From: Patricia Harrell <Pat_Harrell@msn.com>
Sent: Friday, January 27, 2017 11:42 AM
To: Lindsey Ozbolt
Subject: Re: East Lake Sammamish Trail-South Sammamish Segment B section-60% Design Plan comments

Thank you for contacting the City of Sammamish regarding the current Shoreline Substantial Development Permit Application for East Lake Sammamish Trail Segment 2B (SSDP2016-00415).

RE: King County SSDP Permit-- South Sammamish Segment B
Homeowner comments regarding 60% Design Plan
Survey Station 332+00
2221 East Lake Sammamish PL SE

Comments and Concerns for Trail Master Plan Segment B (Sht AL6)

Picture #2

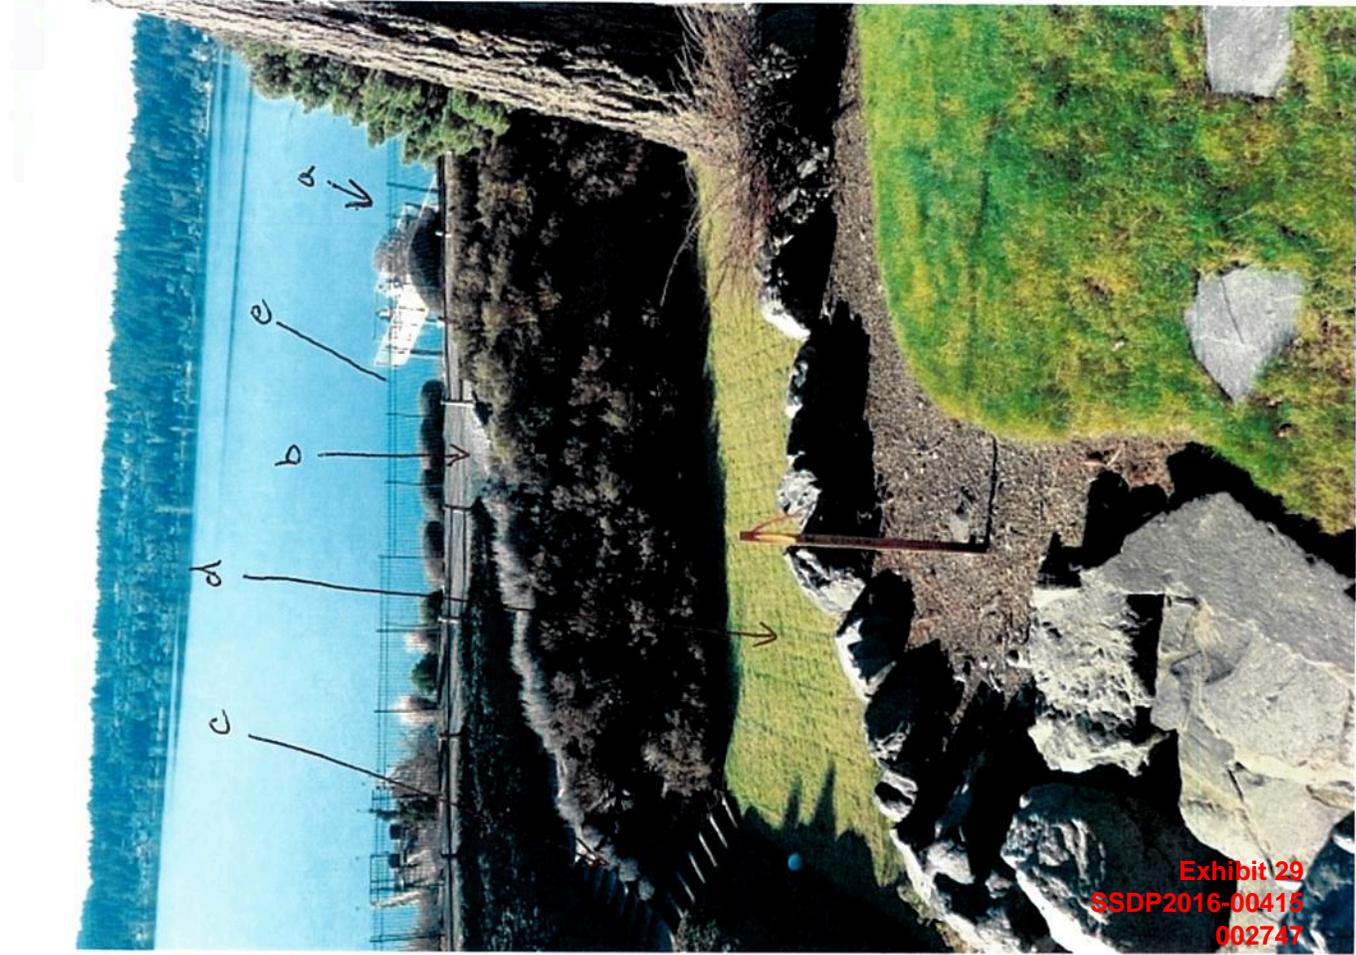
- a. current gate on west side of trail.
Plan does not replace
- b. gate allowing access to current trail and to gate a to dock.
Plan does not replace, thereby cutting off access as new fence on east side has no gate/access.
- c. Stain #36 removed during construction & not replaced?
- d. Aerial view of lower lawn to be 80% replaced with "WBA" (wetland Buffer Addition)!
- e. Current "substantial" fence to be removed with no plan to replace.

Picture # 3

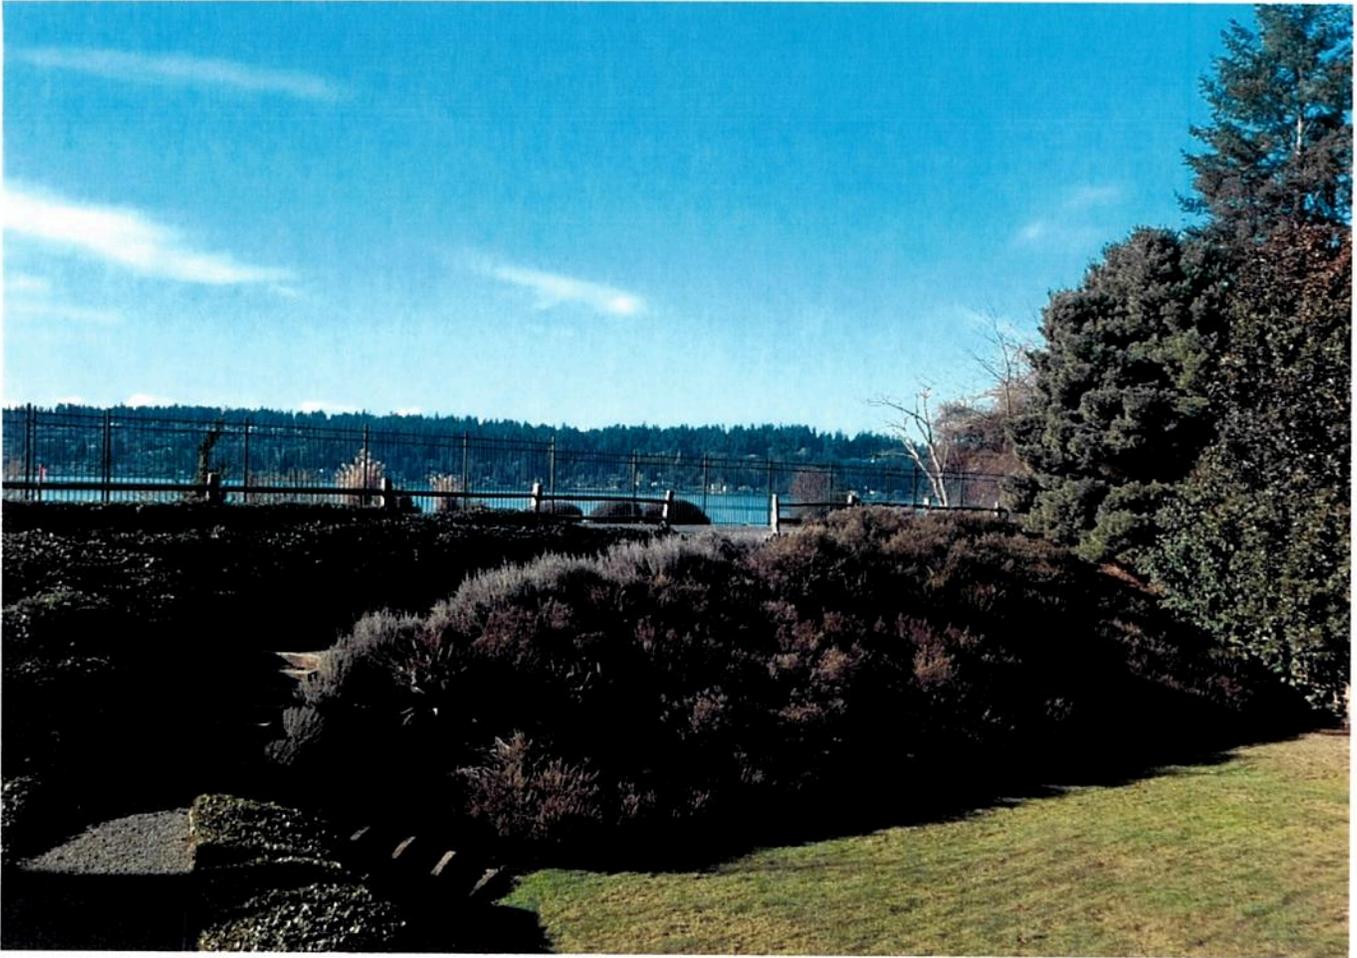
Shows current trail is at grade with fence on west side. Plan calls for removal with no replacement due to need to "clean & grub" 6" to the lakeside of current fence line.

Picture #6

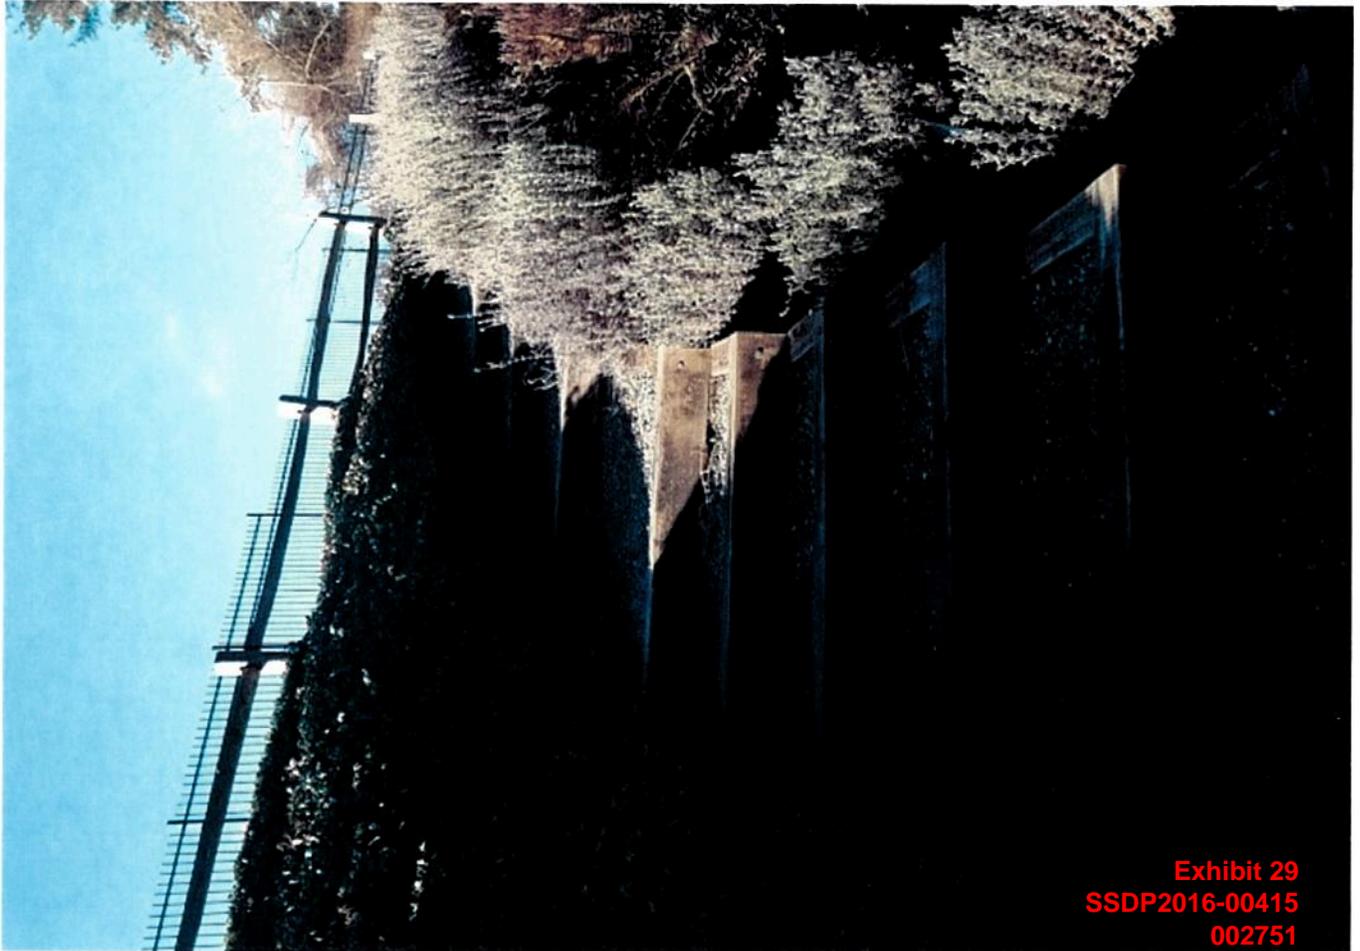
Stair # 36 close up. Only access
to trail/dock. Removed / not
replaced in 60% plan.

Picture # 10

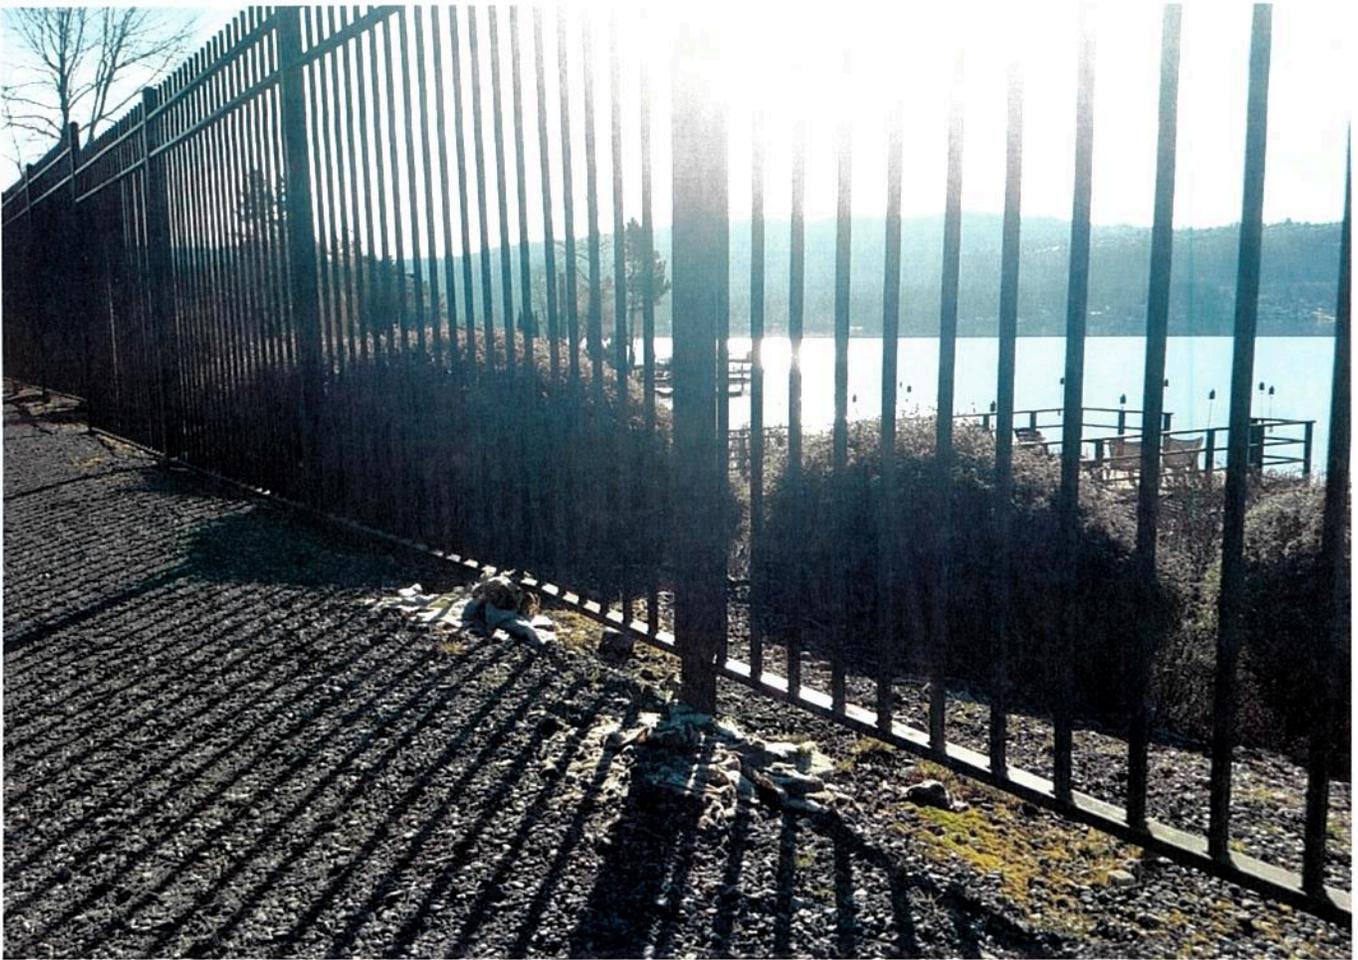
Close up of 700+' of "substantial" fence. Clearly "clearing & grubbing" can be accomplished without the fence's removal. Also indicates that significant erosion is possible if fence is eliminated.

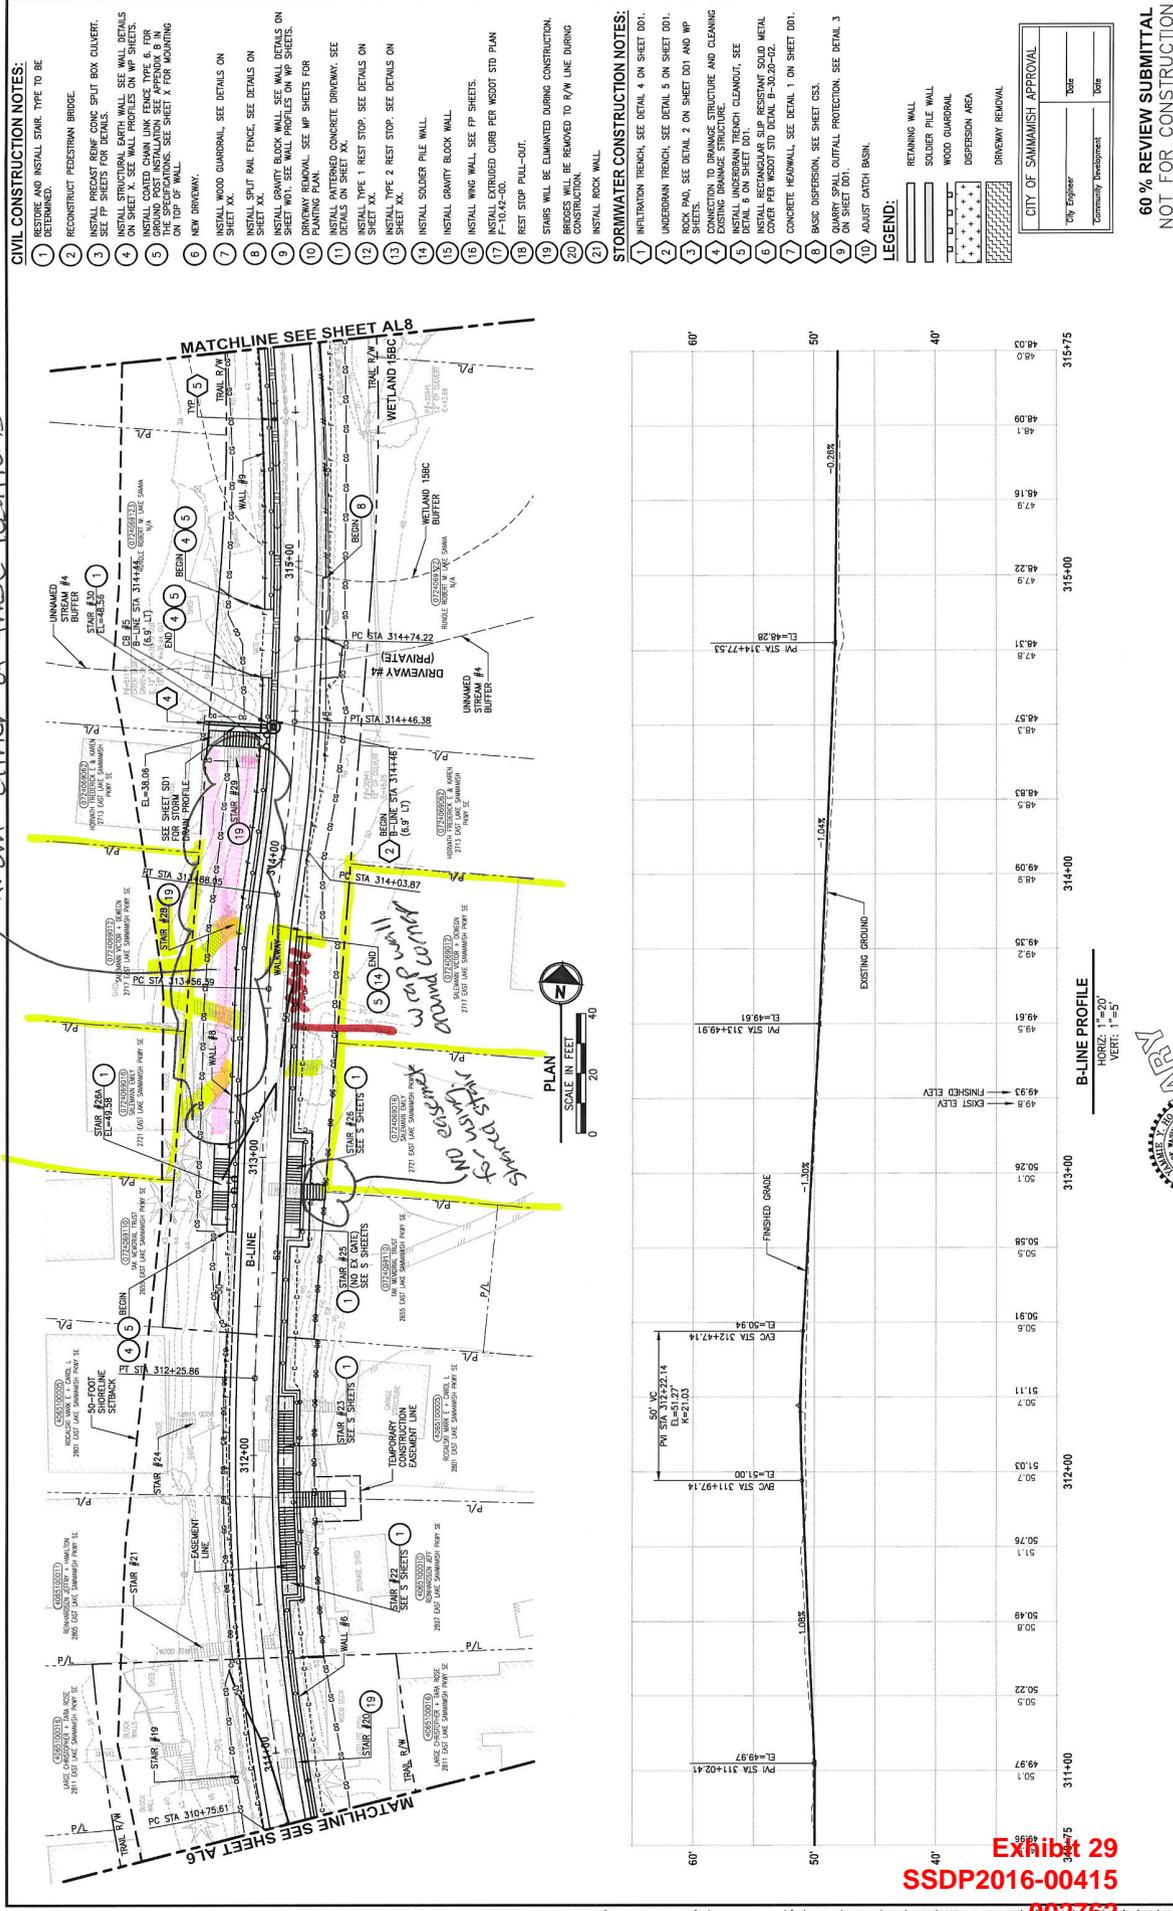
Attached are my comments on the 60% design plans. My biggest concern is the access to our beach from our homes (2721 and 2717). I do not believe the shared stairs north and south of us are feasible due to topography and the location of the existing structures.

Not feasible to get to our beach from either of these locations

WALL #6 WALL PROFILE
 HORIZ: 1"=10'
 VERT: 1"=10'

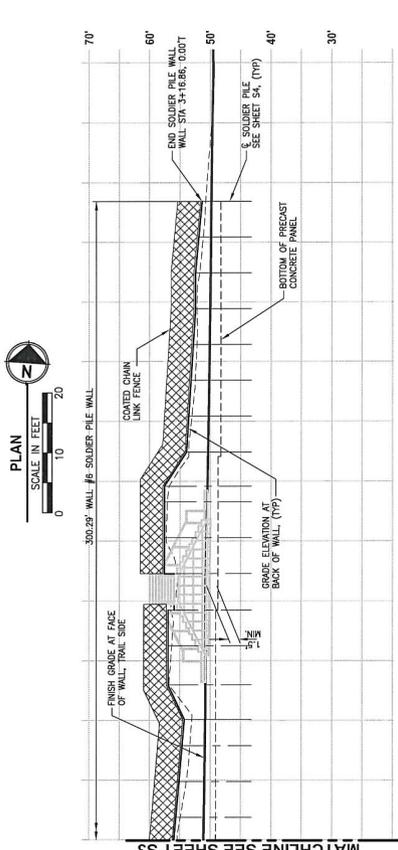
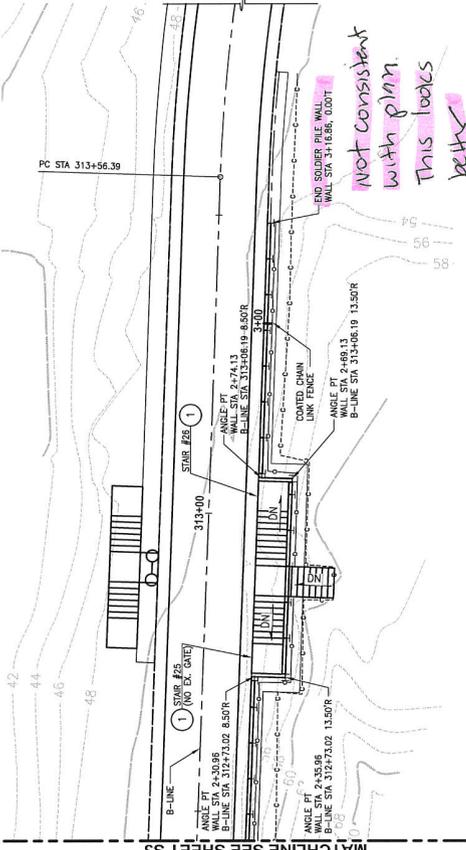
The shoulder pile wall is shown differently on the plan vs the wall detail sheet. The wall detail sheet looks better. I would prefer the wall end at our property line and wrap to the east if needed.

MENEZES
SAMMANISH
JANUARY,
2017

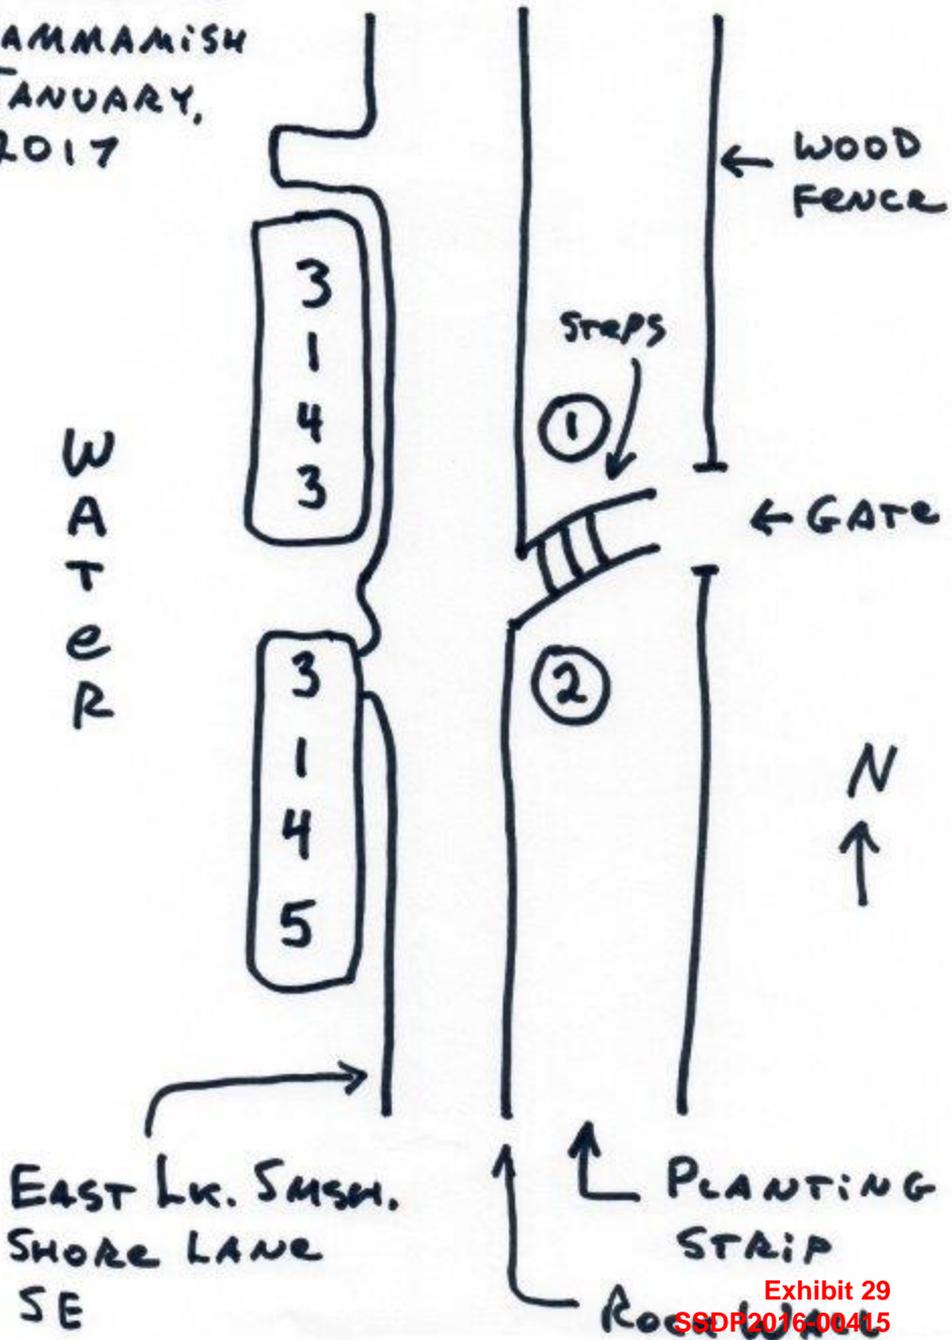
I would request that this significant heritage tree be added to the plans and tree inventory, and would urge that every effort be made to save the tree. I believe this beautiful tree can easily be saved by moving the clearing and grading limits very slightly (approx. 3-4 feet).²
